Preliminary Review of The Katy Corridor Coalition Concept

April 18, 2003

*Prepared for the Houston District of TxDOT
by Parsons Brinckerhoff Quade & Douglas, Inc., GEC*

IH 10 FROM BELTWAY 8 TO WASHINGTON AVENUE

EXHIBIT 2

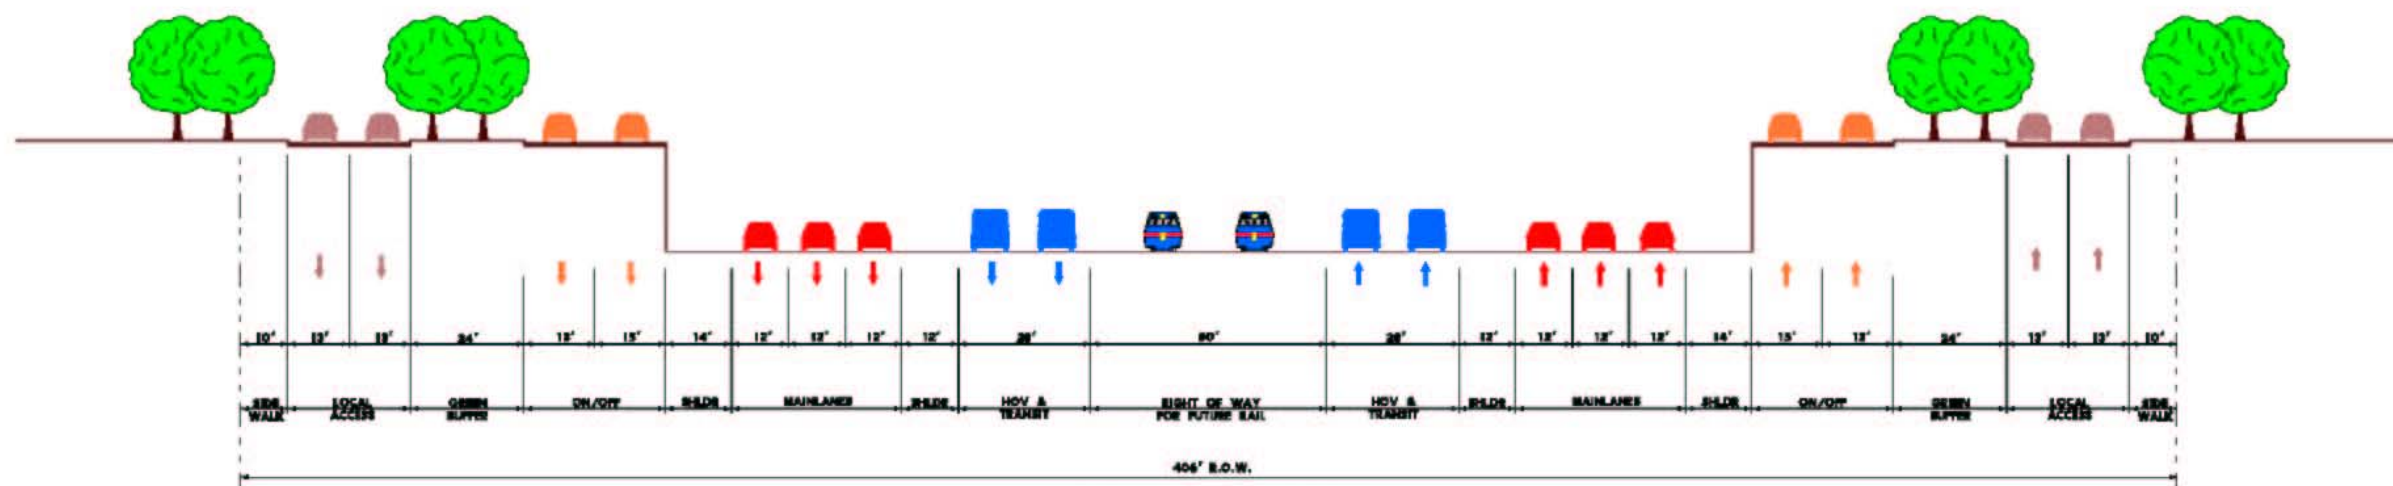
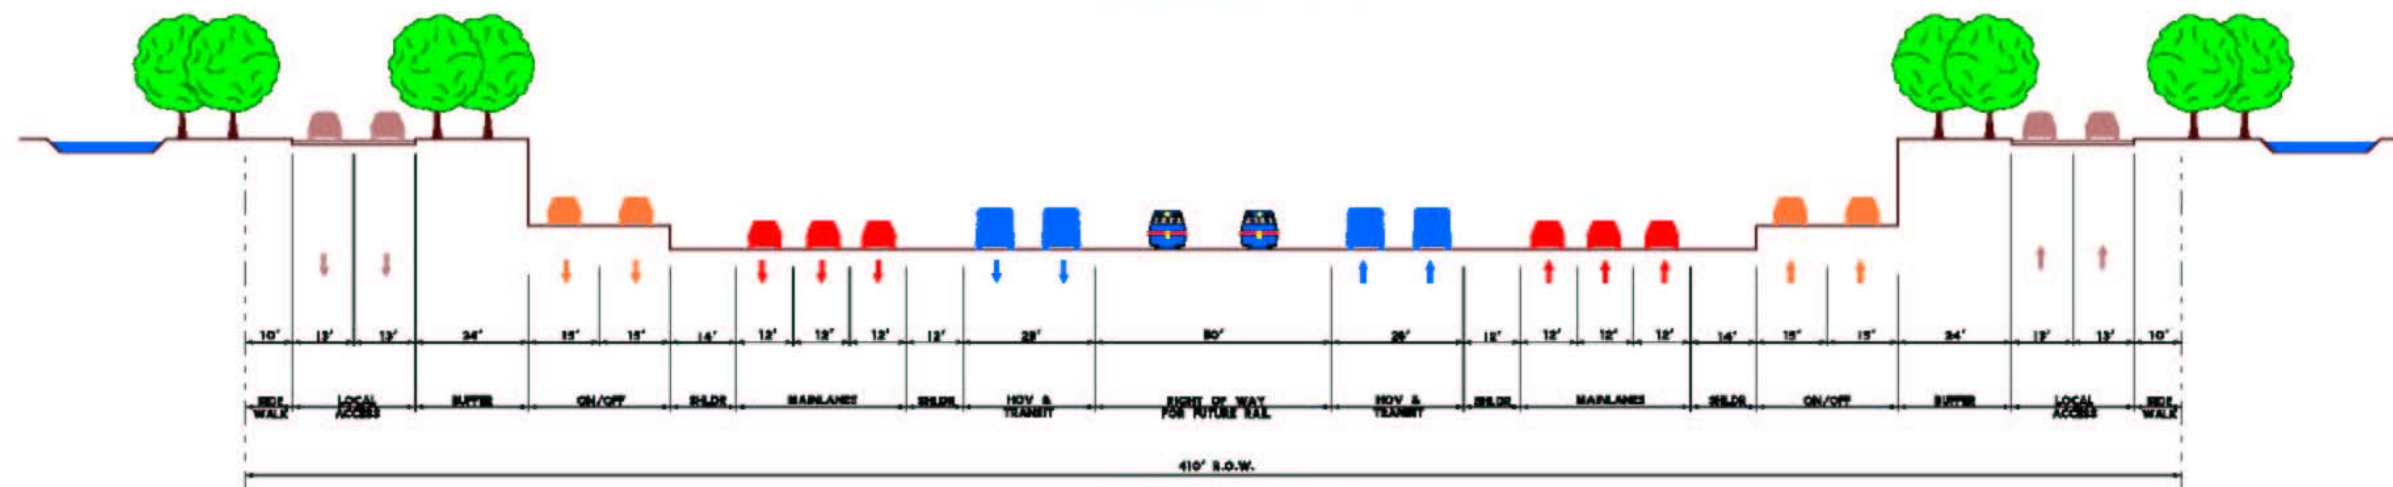
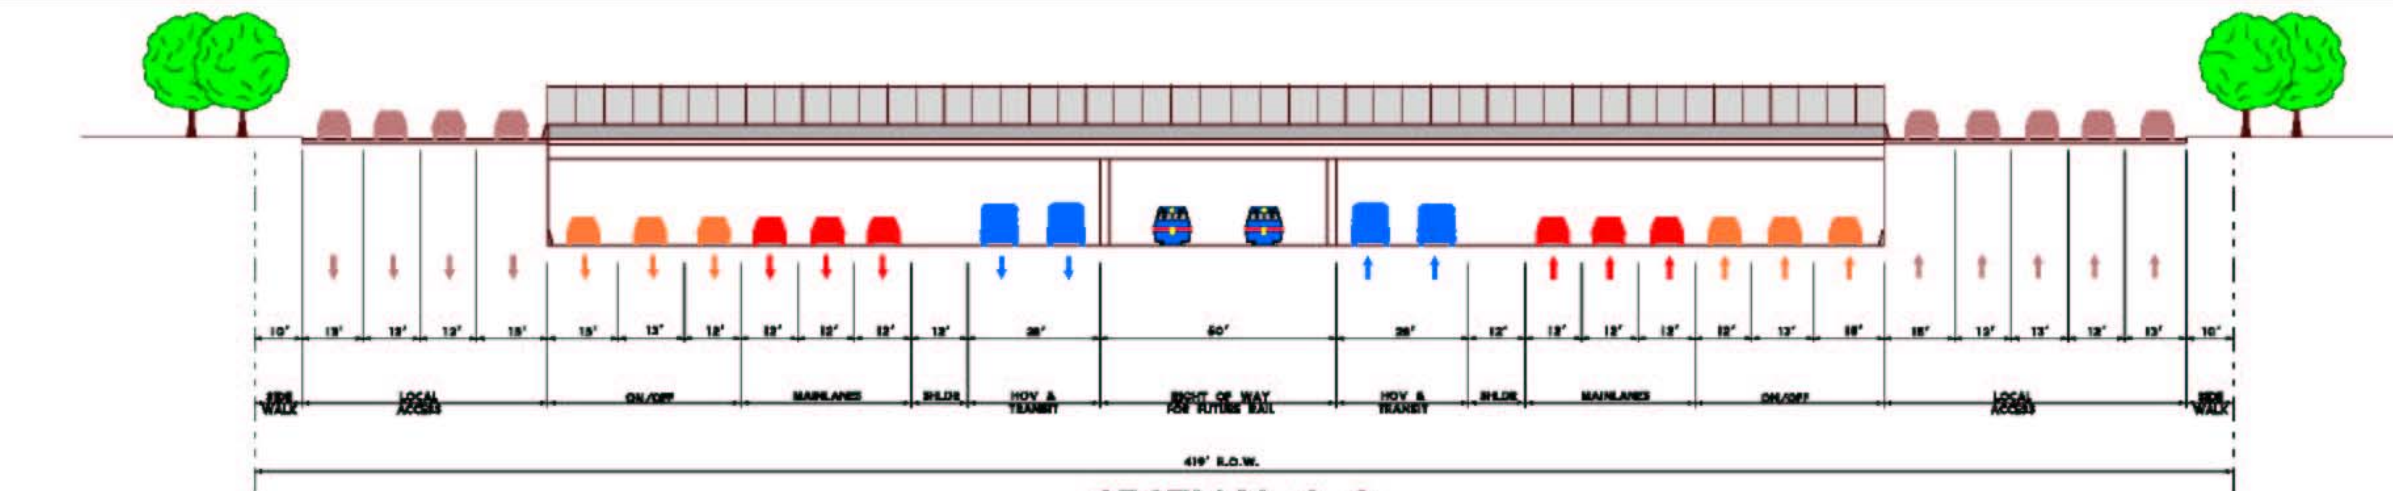
The concept proposed by the Katy Corridor Coalition is shown on the attached Exhibits 2 and 3. Exhibit 2 provides a plan view of a typical segment, depicting the general layout of the various KCC concept subsystems (two HOV/Toll lanes, three main lanes, two collector-distributor lanes with auxiliary lanes, two frontage road lanes and reserved space for future rail). The plan view also shows the approximate location of the three cross-sections included in Exhibit 3. These cross-sections show the lane configurations at the various transition points between the collector-distributor lanes and the adjacent general-purpose main lanes and the frontage roads. The dimensions in the KCC

EXHIBIT 3

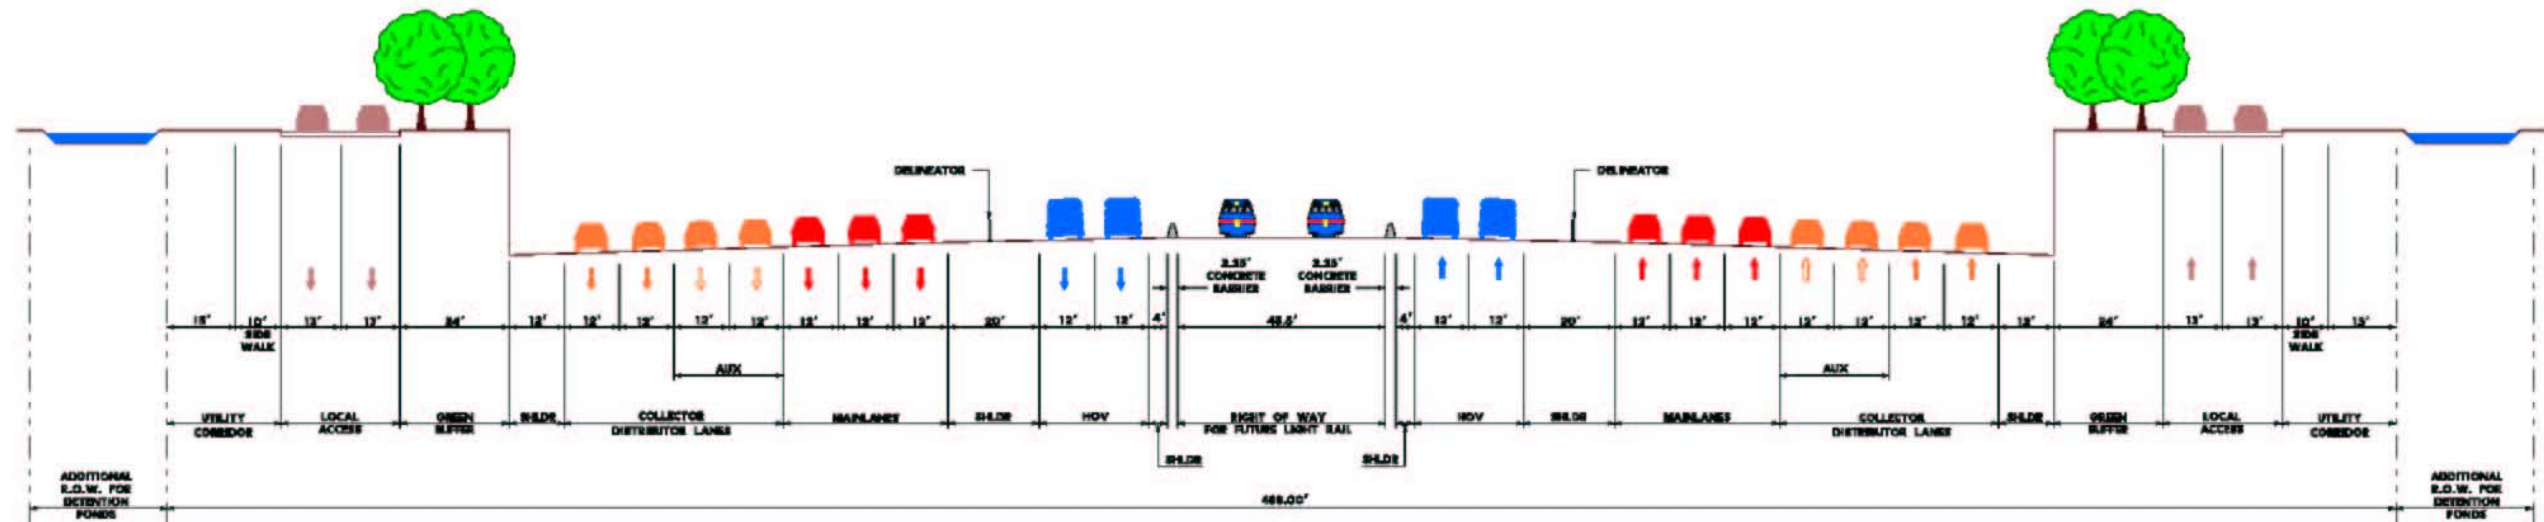
concept cross-sections from the website were difficult to read and therefore the dimensions and other descriptive items in Exhibit 3 were enhanced without changing the basic concept. It is noted that the dimensions were not consistent from one cross-section to another and that the ROW needs varied for each cross-section with a low of 406 feet and a high of 419 feet. Other locations on the KCC website show that their proposed ROW uses the higher value of 419 feet. The cross-sections as shown do not accommodate the proposed outside belt of trees or detention areas that the KCC concept has located outside this 419 feet ROW envelope.

MODIFIED KATY CORRIDOR COALITION CONCEPT

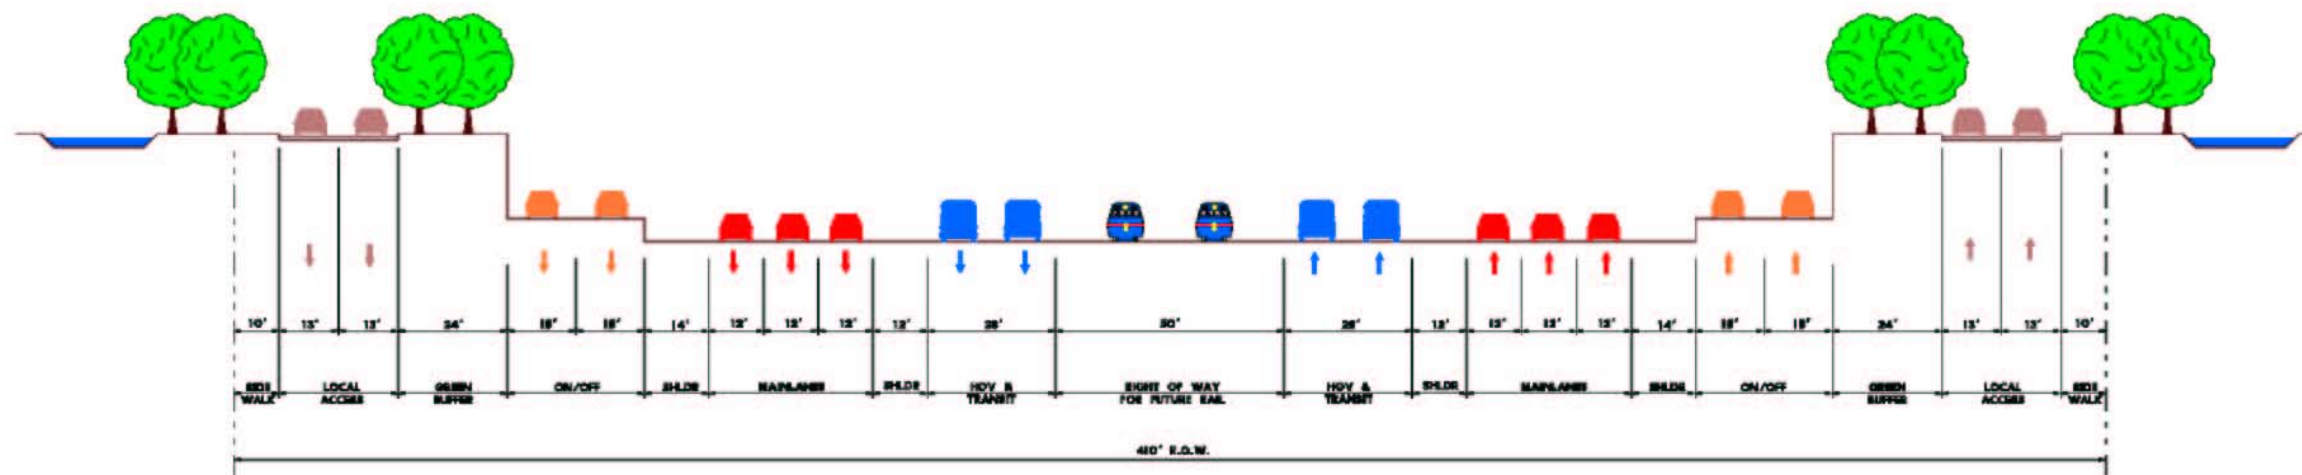
The KCC concept does not meet the current design standards. Therefore, the KCC concept had to be modified to conform with AASHTO and TxDOT standards. Exhibit 4 shows one of the typical KCC cross-sections before and after these modifications. For the purpose of this preliminary review, the following modifications were made:

1. The reserved space for future rail was decreased to 45.5 feet to accommodate concrete barriers separating the rail envelope from the vehicular traffic operations.

2. Inside four-foot buffers were added to the HOV/Toll lanes.
3. The separation between the HOV/Toll Lanes and the mainlanes was increased from 12 to 20 feet, in each direction, to provide minimum 10-foot shoulders for each of the facilities (the desirable standard is 24 feet).

4. The CD lanes are maintained at the same grade level as the main lanes throughout because of insufficient distances between cross street structures to allow the CD lanes to rise to the frontage road levels and down again.

5. An additional CD auxiliary lane in each direction has been added in the middle segment of the CD facility because of the traffic demands.
6. The CD facility has been further modified from two 15-foot lanes to two 12-foot lanes with an outside 12-foot shoulder.

7. The outside border width has been increased from 10 feet to 25 feet to accommodate utilities.

These modifications increased the ROW width under the KCC concept to 488 feet, slightly more than the TxDOT IH 10 Project Plan, and serve as the basis for the preliminary review. It should be noted that space for additional detention areas or green space for planting of trees along the edge of the facility as indicated in the KCC concept would add to the ROW requirements.

IH 10 Katy Freeway Corridor IH 610 to Beltway 8 Local Through Lane Ramping Minimum Lane Requirements

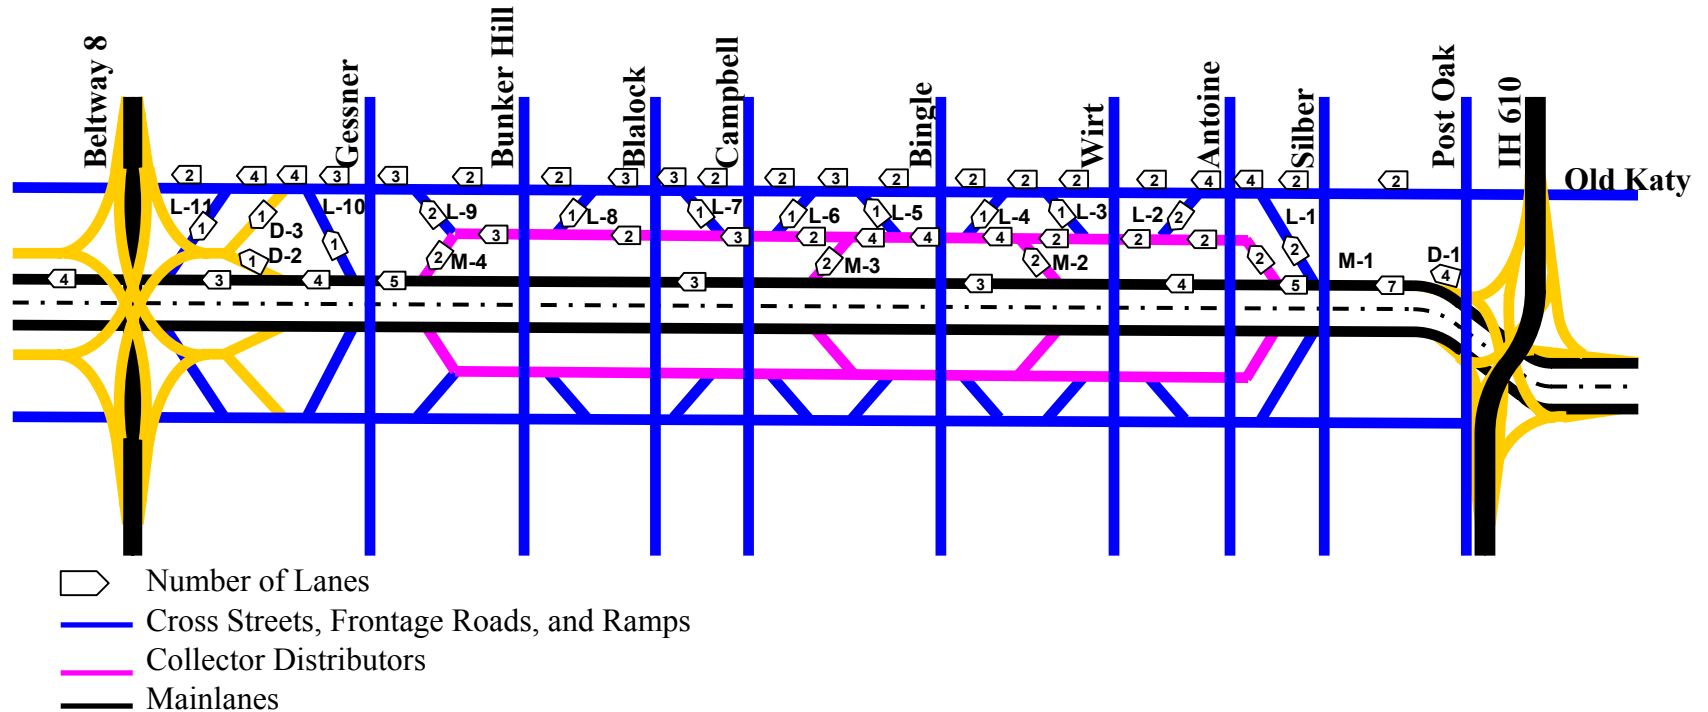
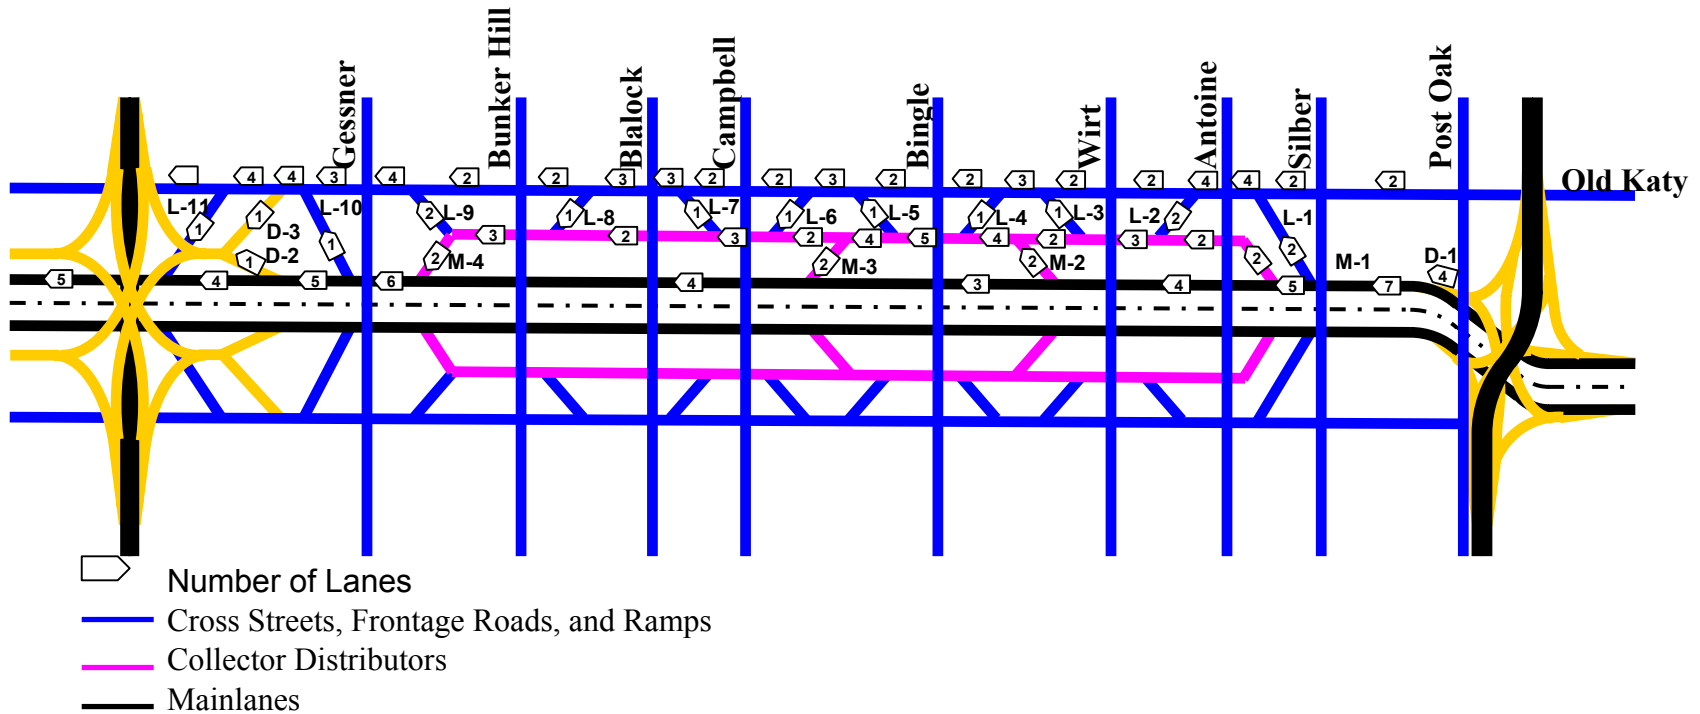
The basis for the Modified Typical Section is supported by the TxDOT IH 10 Project Plan Origin Destination Table (Exhibit 5) and minimum lane requirements analysis shown in Exhibit 6. A further preliminary analysis was performed to determine the minimum number of lanes required to achieve lane balance. The results of this analysis are shown in Exhibit 7. This preliminary analysis was very limited in scope and would require extensive further analysis of an actual operative system.

Bouyancy

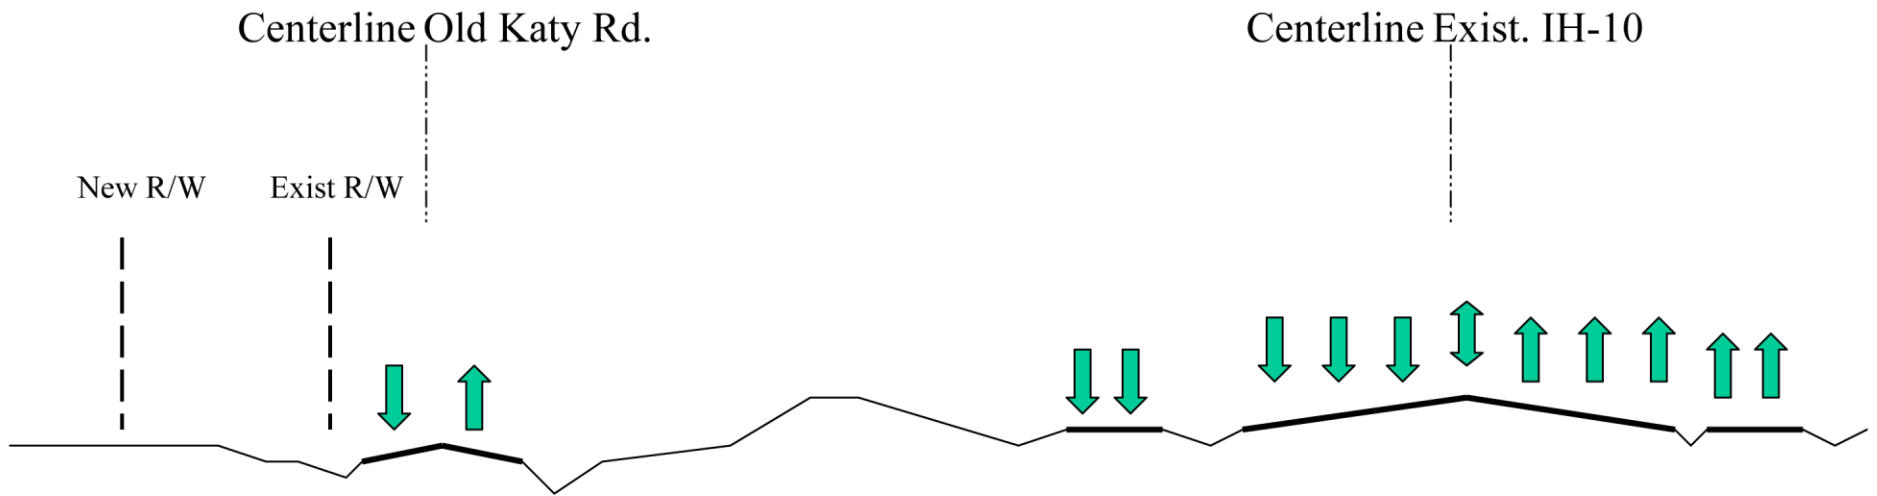
I believe that any utility buried beneath the pavement in the depressed section should be designed to resist buoyant uplift since we can't guarantee that a buoyant condition will never occur. The methods to resist this would be to bury the culverts deep enough that the buoyant weight of soil above the culvert is enough to resist the buoyant force, to thicken the bottom slab of the culvert to add weight to the culvert, or possibly to construct shelves off the side of the culvert to provide additional vertical resistance due to the weight of the soil above the shelves.

The buoyant unit weight of soil can be taken as 60 pcf. The buoyant weight of concrete should be taken as about 85 pcf. You can analyze the box based on the anticipated burial depth to see how much net buoyancy remains to be resisted after the weight of soil above the box and the weight of the box concrete is accounted for. I believe that either the base thickening or the shelf idea should be enough to get a suitable buoyancy resistance.
